• **VIBRATION—VIBRATION FELT AT HIGH SPEEDS—TRANSMISSION OUTPUT SHAFT BUSHING OR SEAL DAMAGED OR OUT OF POSITION—4X2 MODELS EQUIPPED WITH 4R70W AUTOMATIC TRANSMISSION AND 139 INCH WHEELBASE ONLY—BUILT BEFORE 3/1/2001** • **TRANSMISSION—4R70W—TRANSMISSION OUTPUT SHAFT BUSHING OR SEAL DAMAGED OR OUT OF POSITION—4X2 MODELS EQUIPPED WITH 4R70W AUTOMATIC TRANSMISSION AND 139 INCH WHEELBASE ONLY—BUILT BEFORE 3/1/2001**	**Article No. 01-9-1**

FORD: 2001 F-150

Figure 1 - Article 01-9-1

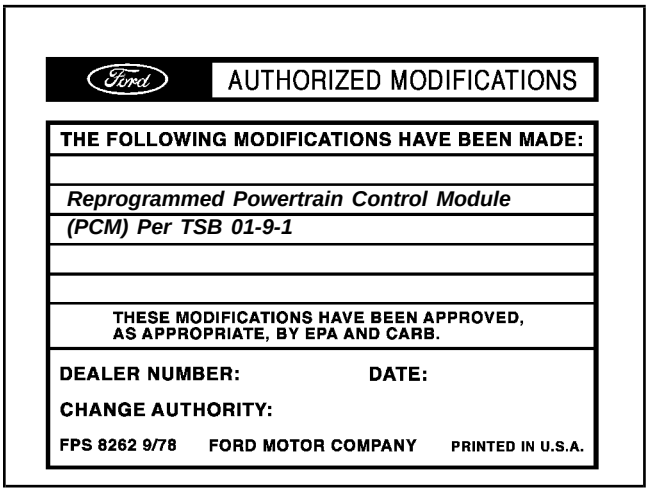
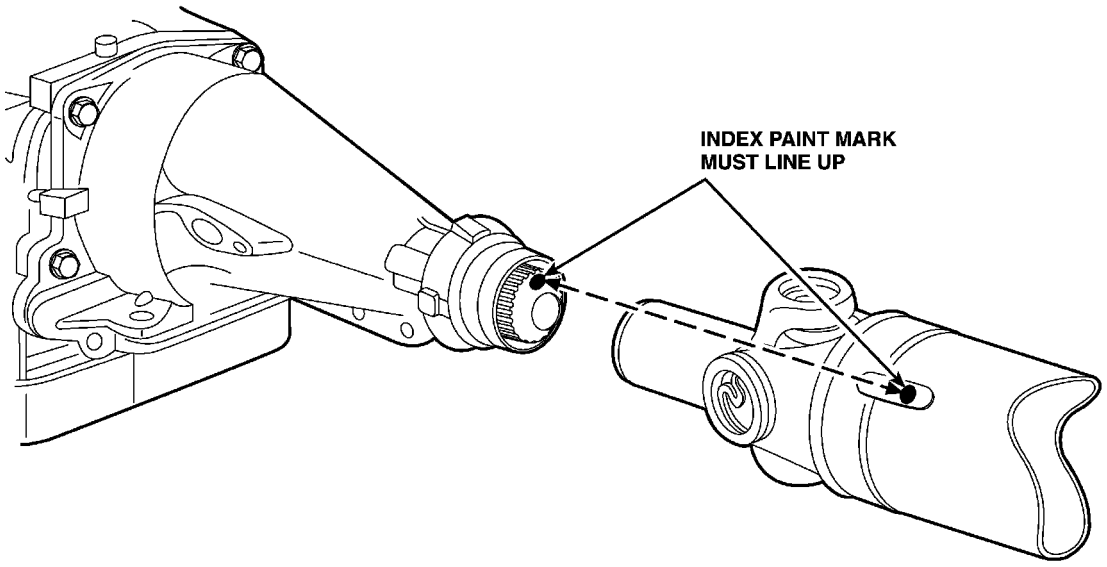
THE INDEX PAINT MARKS ON THE OUTPUT SHAFT, DRIVESHAFT, AND REAR AXLE MUST BE ALIGNED. THE INDEXED BALANCE MARK ON THE OUTPUT SHAFT AND THE INDEXED BALANCE MARK ON THE NEW DRIVESHAFT YOKE MUST BE ALIGNED (FIGURE 1). ALIGNMENT OF THE INDEX MARKS ON THE REAR DRIVESHAFT TUBE AND THE REAR AXLE FLANGE MUST BE PERFORMED (FIGURE 2).
